UNITED STATES PATENT AND TRADEMARK OFFICE

APPLICATION NO.	FILING DATE	FIRST NAMED INVENTOR	ATTORNEY DOCKET NO.	CONFIRMATION NO.
10/003,404	12/06/2001	Koji Nii	027260-505	5384

Office Action Summary

FIG. 20

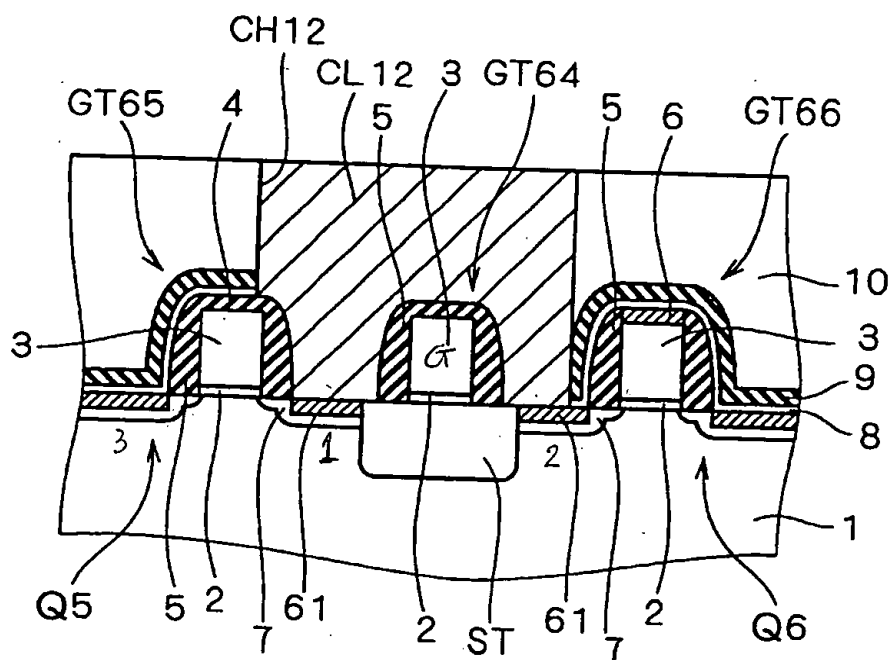
With regard to claim 1, Igarashi et al. disclose a gate electrode 3 formed on a substrate 1 through a gate insulating film 2 lying therebetween; first and second diffused layers formed opposite to each other across the portion of the substrate 1 existing under the gate electrode 3 and having a first conduction type, each having a second conduction type different from the first conduction type of the portion; a contact CL12 formed within a contact hole CH12 on the substrate 1. (Note attachment # 1 of Fig. 20 of Igarashi et al.).

With regard to claim 2, Igarashi et al. discloses the contact CL12 is connected also to the second diffused layer. (Note attachment #1 of Fig. 20 of Igarashi et al.).

FIG. 20

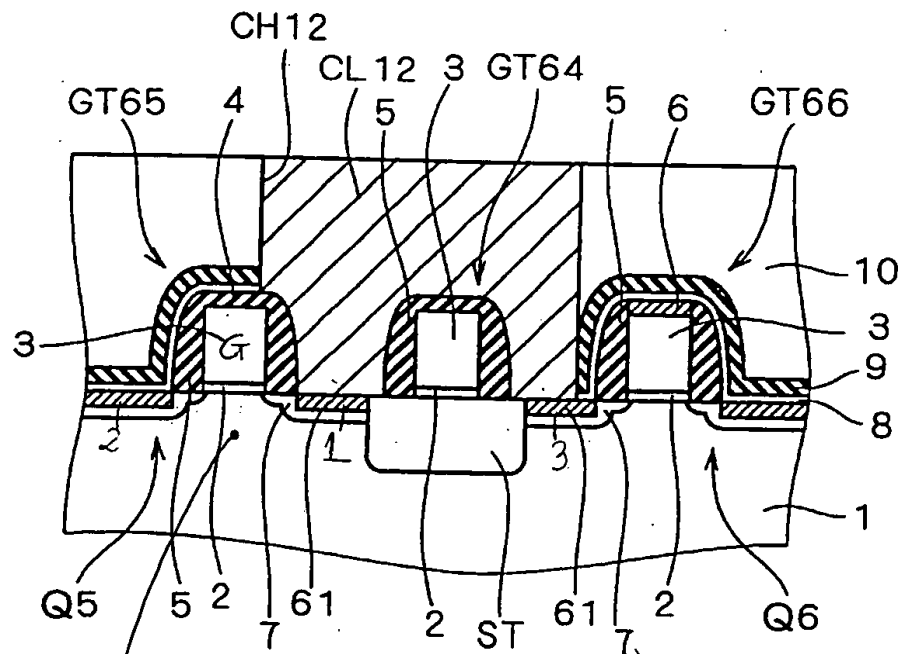
separates the first and the third diffused layers each other; wherein the contact CL12 is connected further to the third diffused layer. (Note attachment # 2 of Fig. 20 of Igarashi et al.).

With regard to claim 4, Igarashi et al. disclose a gate electrode 3 formed on a substrate 1 through a gate insulating film 2 lying therebetween; a diffused layer formed on the substrate having first and second diffused portions formed opposite to each other across the portion of the substrate 1 existing under the gate electrode 3 and having a first conduction type, each having a second conduction type different from the first conduction type of the portion of the substrate and a third portion that connects the first portion to the second portion; a contact CL12 formed within a contact hole CH12 on the substrate 1, (Note attachment # 2 of Fig. 20 of Igarashi et al.).

With regard to claim 6, Igarashi et al. discloses another diffused layer formed on the substrate 1; and an isolation area ST formed between the first portion of the diffused layer and the another diffused layer, which separates the first portion of the diffused layer and the another diffused layer, wherein the contact is connected further to the another diffused layer. (Note attachment # 2 of Fig. 20 of Igarashi et al.).

3rd portion connects
1st portion to the 2nd portion
of the diffused layer

another diffused layer-
